Technical product information

Topic	Bentayga V8 Kovomo - DTC P227900 evident within the engine control unit 0001
Market area	United States E05 Bentley USA and rest America (6E05)
Brand	Bentley
Transaction No.	2071575/2
Level	EH
Status	Approval
Release date

Figure 2

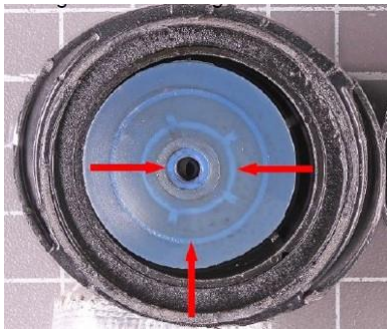
Hint: The diaphragm of 0P2 103 210G and 0P2 103 211H are blue (Figure 2)

Figure 4

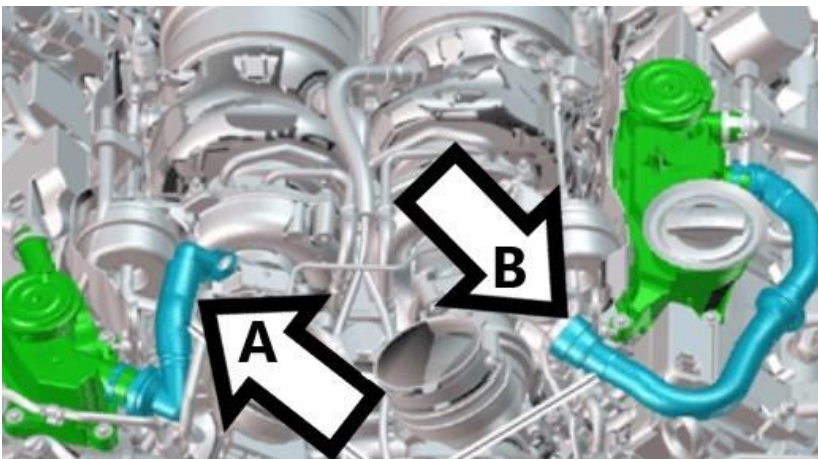
1) Referring to Rep.Gr 21 - Replace the bank 1 (right) and bank 2 (left) turbocharger full load pipes

Note: when conducting the instructions within this TPI please ensure the bank 1 and bank 2 turbocharger full load pipes are replaced in pairs (during the same workshop visit)

Referring to Figure 4

- Point A - Is the bank 1 (right) turbocharger full load pipe
- Point B - Is the bank 2 (left) turbocharger full load pipe

Figure 5

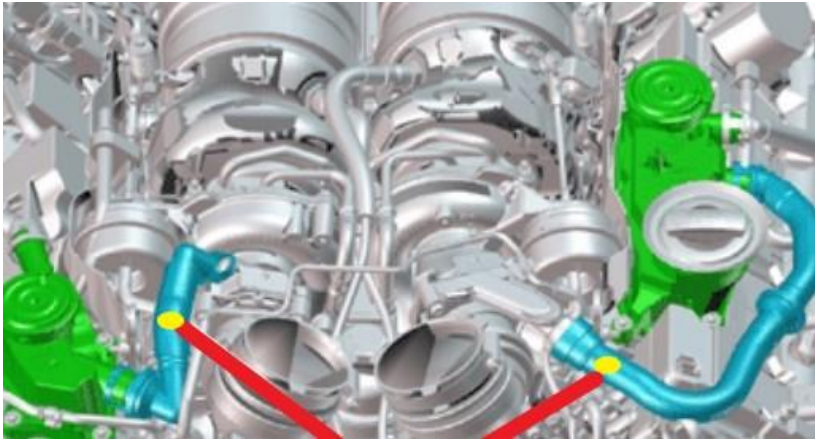
2) To confirm both pipes have been replaced using the H level parts the operative must place a yellow paint mark as shown in Figure 5
